## 1981 FXB CHANGES

## Rear Sprocket Mounting

Figure 1. Correct Belt Drive Compensating Sprocket Assembly

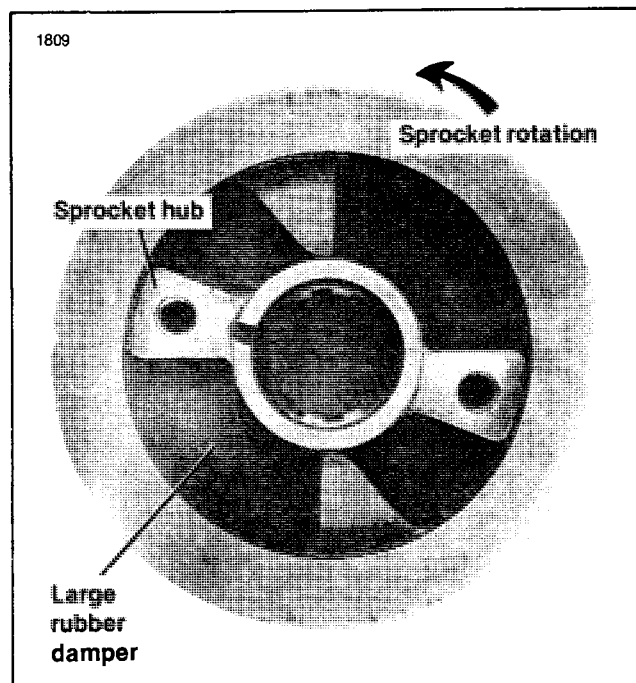
Figure 6-7 on page 6-6 of the 1978½ to 1981 FL/FX Service Manual may need some clarification. The exploded view drawing is correct as viewed with parts installed on the motorcycle. The photograph (1684) shows the sprocket rubber dampers and hub from the back side. Installed properly on the motorcycle, the sprocket, dampers and hub should look like Figure 1 when viewed from the left side of the motorcycle. This is important since the square surface of the sprocket projections must receive the load from the hub as transmitted through the large rubber dampers. If the sprocket and/or rubber dampers are reversed, excessive noise and/or parts wear may occur.

When assembling the compensating sprocket, always check the clearance between the outer FLANGE BEARING, Part No. 40254-80, and the sprocket. If the clearance exceeds .0015 in., replace the flange bearing. Excessive clearance may lead to misalignment of the sprocket and excessive parts wear and noise.

Figure 2. Old and New Style Starter Shafts

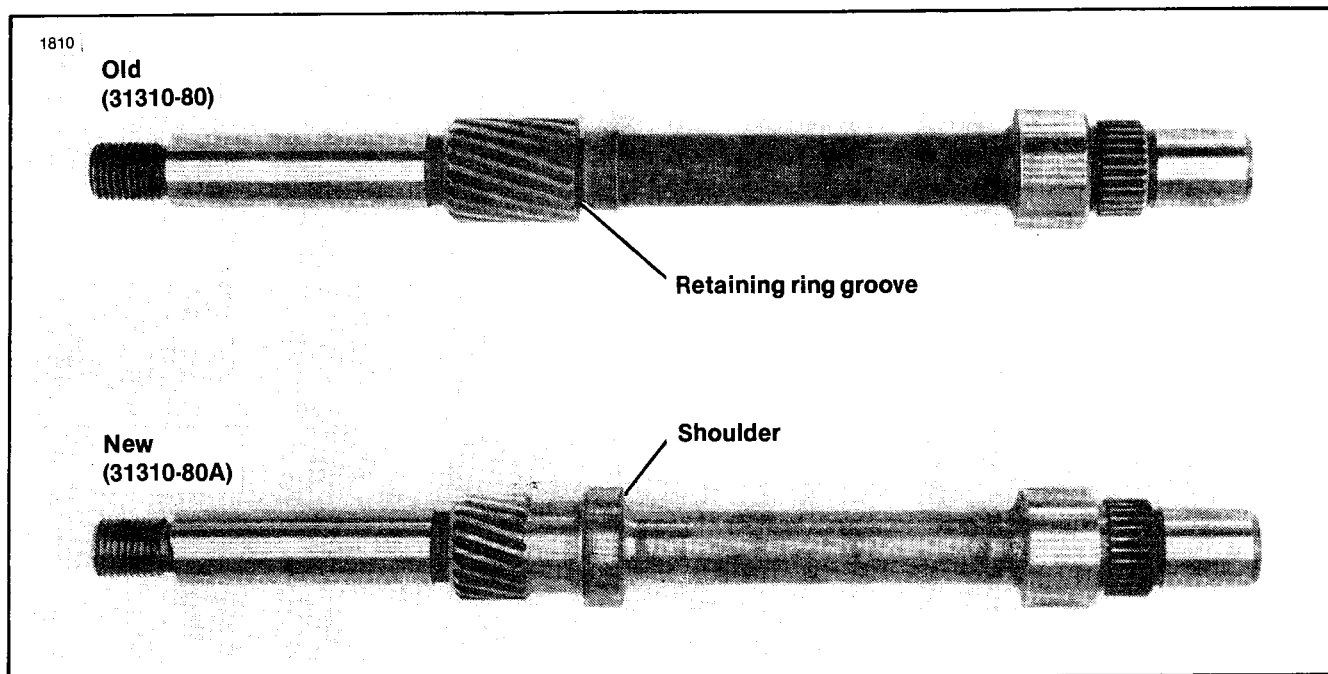
Starting with VIN 1HD1BDK12BY017428, all 1981 FXB models have a new style STARTER SHAFT, Part No. 31310-80A. This shaft has an added shoulder in place of

the retaining ring groove and RETAINING RING, Part No. 31313-80, as shown in Figure 2. The new shaft is a direct replacement for the old and should be used whenever replacing a starter shaft on 1980 or 1981 FXB models.
